STAFF RECOMMENDATION 904 Bradford Avenue August 17, 2016

Application: New construction—detached accessory dwelling unit; Setback determination

District: Waverly-Belmont Neighborhood Conservation Zoning Overlay

Description of Project: Application is to construct a detached accessory dwelling unit (DADU) at the rear of the lot. The structure requires a rear setback determination from twenty feet (20') to ten feet (10').

C **SITE PLAN**

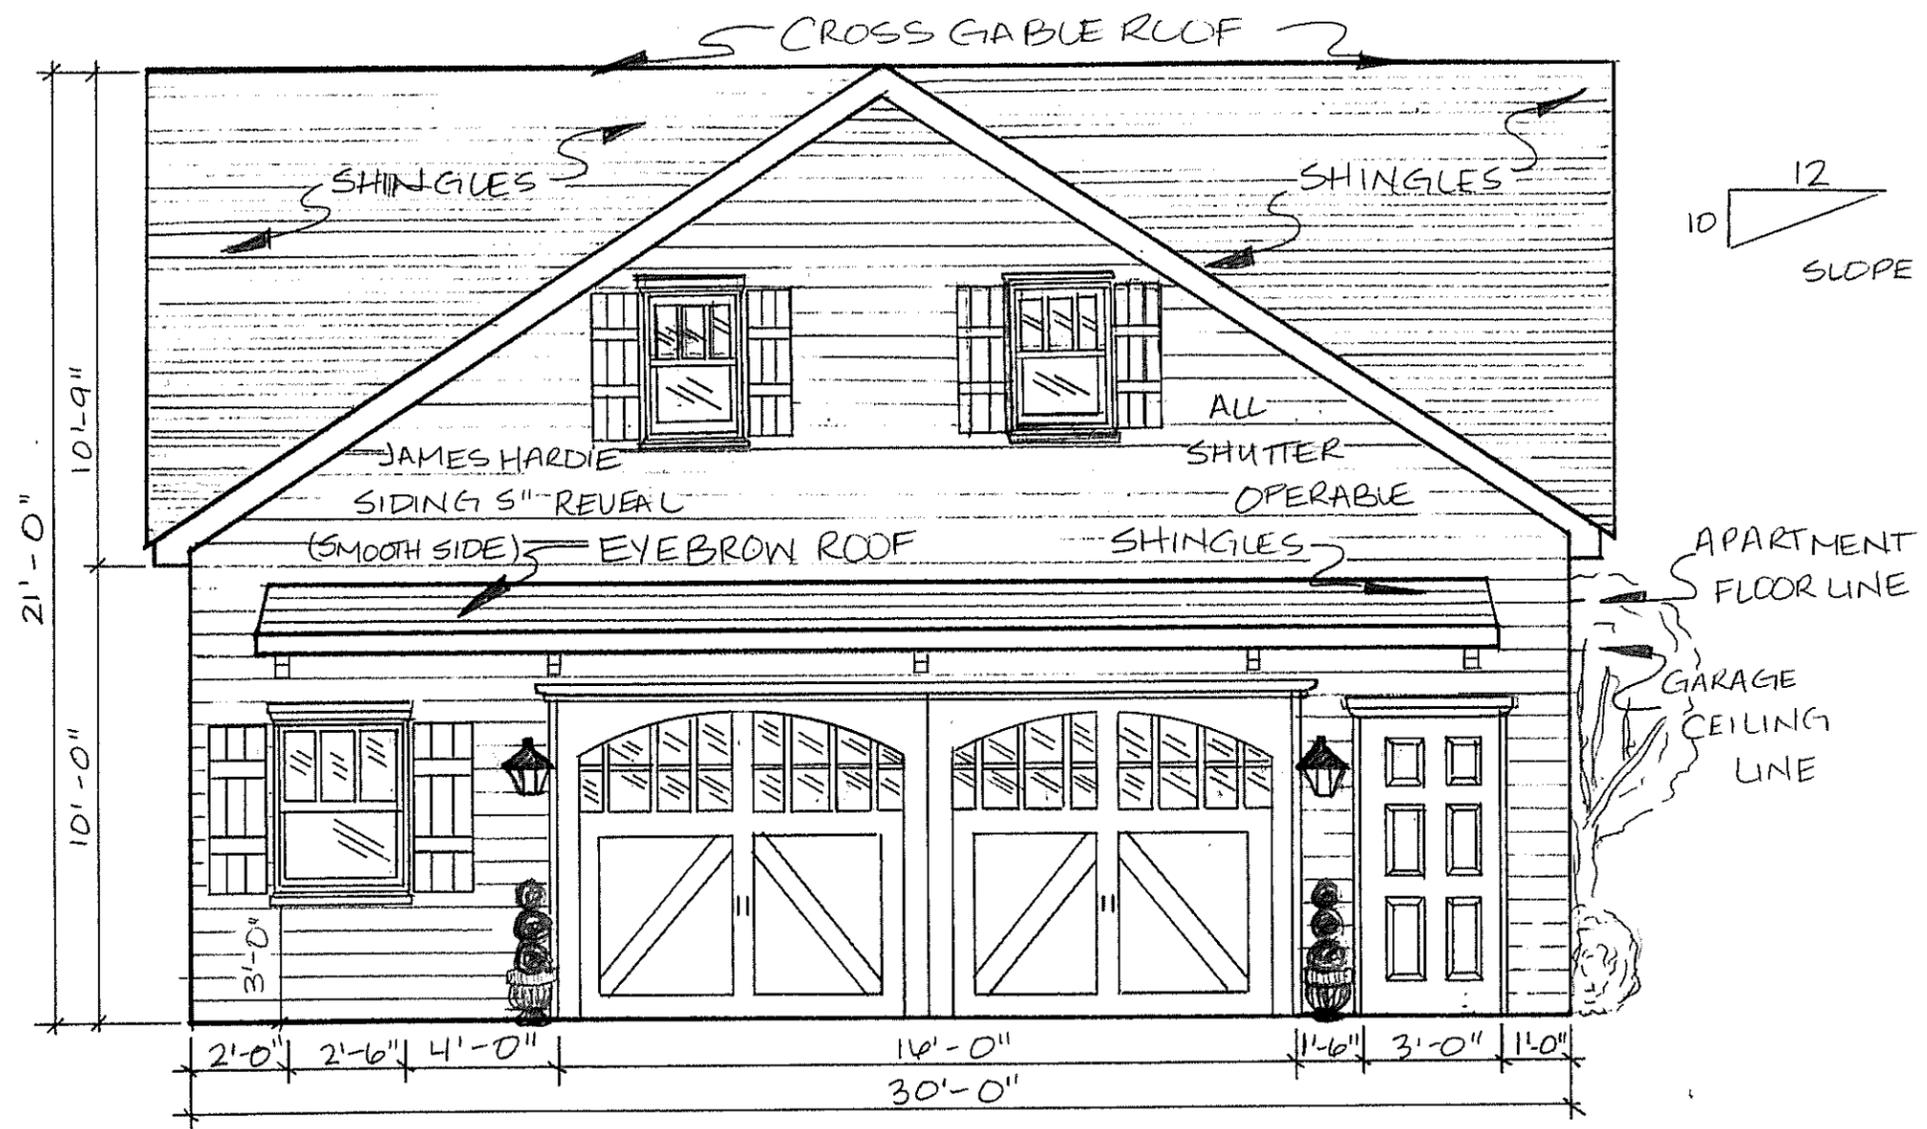
The new DADU does require a rear setback determination. When an outbuilding has a footprint greater than seven hundred square feet (700 sq. ft.), base zoning requires that the structure be located twenty feet (20') from the rear property line and five feet (5') from the side property lines. In this instance, the structure is located at least five feet (5') from the side property lines, but it is located ten feet (10') from the rear property line. Staff finds that the proposed rear setback is appropriate because a ten foot (10') setback is the standard rear setback for structures that are seven hundred square feet (700 sq. ft.) or less. Also, historically, outbuildings were located at the rear of the property, close to the rear property line. A ten foot (10') rear setback is more historically appropriate than a twenty foot (20') rear setback. In addition, the ten foot (10') rear setback allows for more space between the primary structure and the outbuilding. Staff recommends approval of the setback determination.
